**Flood Control Project Maintenance
Levee Inspections**
LMA District Cover Sheet
Spring 2020 Levee Inspection Results

Reclamation District No. 2035 Conaway

Levee Inspection Report By Mile - Spring 2020

Photo 1 of 1 : SP_2020_RD2035_240_5_20200228_00001.jpg

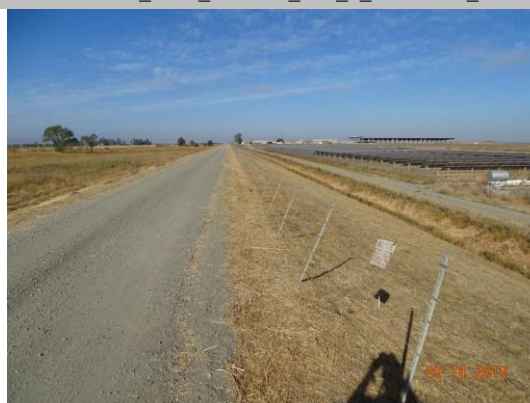
LM Start	2.23	Rating **	M	Issue No.	5
LM End	2.51	Issue Type +	En	Location *	LS
Category	Earthen Levee			GPS Latitude/Longitude	
				Start	End
Item	Encroachments			38.590893 °	38.590760 °
				-121.659942 °	-121.665210 °
DWR ID	DWR_RD2035_03_s_2013_5				
Comment Code					
FE : Fence					
Inspector Comment
